UNITED STATES PATENT AND TRADEMARK OFFICE

Office Action Summary

10/789,597

Long, Figure 5

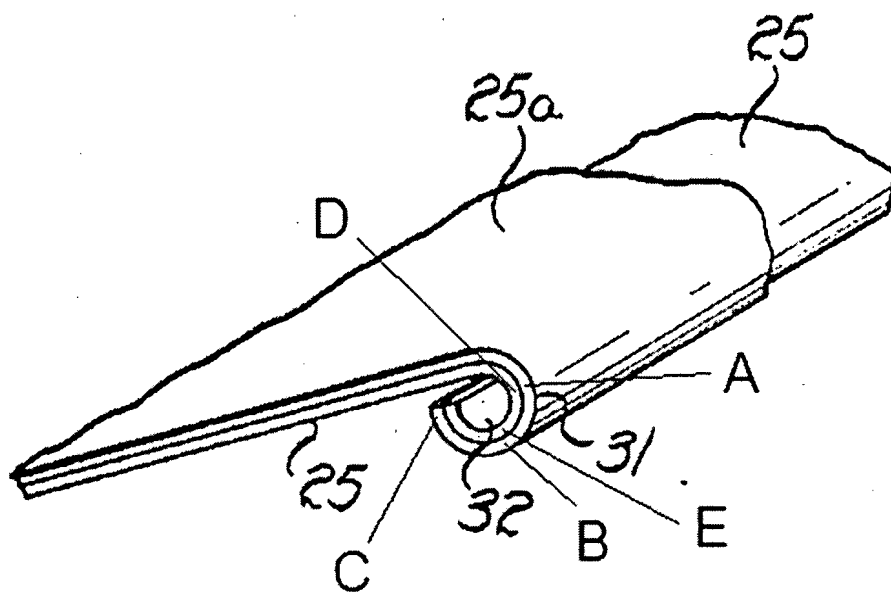
c. Regarding Claim 3, Long teaches that the second flange (31) includes a first portion (A) extending from and substantially orthogonal to the planar second portion, a second portion (B) orthogonal to the first portion and a lip portion (C) extending toward the planar portion.

- d. Regarding Claims 4 and 9, Long teaches that the second flange is substantially C-shaped (See Figure 5).
 - e. Regarding Claim 5, Long teaches that the first flange (32) includes a first portion (D) extending orthogonal to the planar portion of the first member, a second portion (E) extending substantially orthogonal from the first portion and wherein the second portion of the first flange is telescopingly received between the second and lip portions of the second flange (portion E is situated substantially between portions B and C).

j. Regarding Claim 14, Long teaches that the second flange (31) includes a first portion (A) extending from and substantially orthogonal to the planar second portion, a second portion (B) orthogonal to the first portion and a lip portion (C) extending toward the planar portion.

l. Regarding Claim 16, Long teaches that the first flange (32) includes a first portion (D) extending orthogonal to the planar portion of the first member, a second portion (E) extending substantially orthogonal from the first portion and wherein the second portion of the first flange is telescopingly received between

the second and lip portions of the second flange (portion E is situated substantially between portions B and C).
